PCN # 254
Notification Date:
March 8, 2024

Product / Process Change Notice

The CBRDFSH2-40 Schottky bridge rectifier manufactured in the BR DFN case.

Table 1:

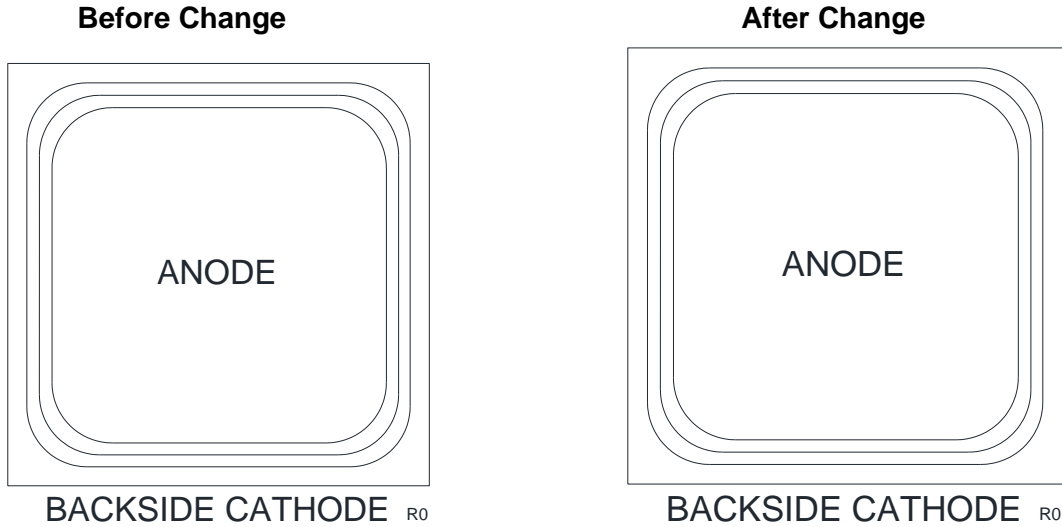
Change in wafer fab, resulting in change in die size from 40 x 40 mils to 46 x 46 mils (see Table 1).

Die Size	40 x 40 MILS
Die Thickness	10 MILS
Anode Bonding Pad Size	36 x 36 MILS
Top Side Metalization	Ti/Ni/Ag
Back Side Metalization	Ti/Ni/Ag

Die Size	46 x 46 MILS
Die Thickness	11.8 MILS
Anode Bonding Pad Size	41.8 X 41.8 MILS
Top Side Metalization	Ti/Ni/Ag
Back Side Metalization	Ti/Ni/Ag
